BOARD OF ADJUSTMENT CASE REPORT

STR: 0225 CD: 1 Case Number: BOA-23622

LOCATION: 349 E. Zion Pl. N.

CITY OF TULSA CORRECTIONS SUMMARY

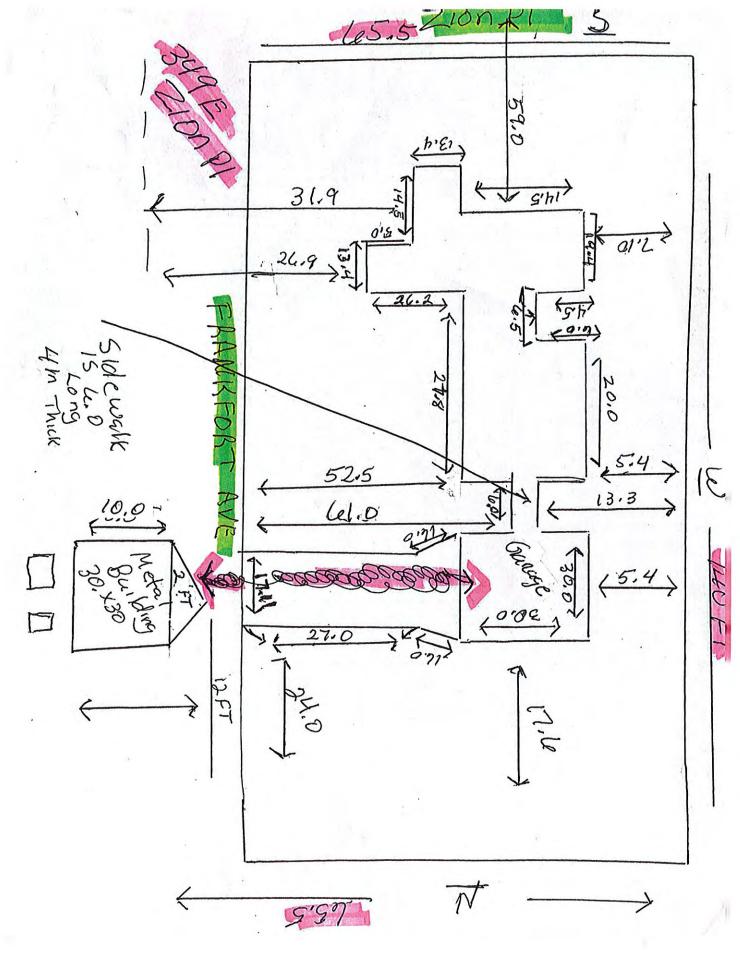
Subject: Zoning Review Page Label: 1 Status: Author: DWhiteman Date: 4/12/2023 4:03:37 PM Color:

Section 45.030-A.2: Accessory Building Size, RS-2, RS-3, RS-4, RS-5 and RM Districts In RS-2, RS-3, RS-4, RS-5 and RM zoned lots used for detached houses or duplexes, the total aggregate floor area of all detached accessory buildings. including accessory dwelling units, and accessory buildings not erected as an integral part of the principal residential building may not exceed 500 square feet or 40% of the floor area of the principal residential structure, whichever is greater. **REVIEW COMMENT: According to the county** assessor's website, the floor area of the principal residential building is 1,304 square feet; therefore, the maximum allowable floor area of all accessory buildings for your lot is 522 square feet (1,304 square feet x 40%). The proposed accessory building floor area will be 900 square feet. This exceeds the allowable size of accessory buildings on your lot and cannot be approved as proposed.
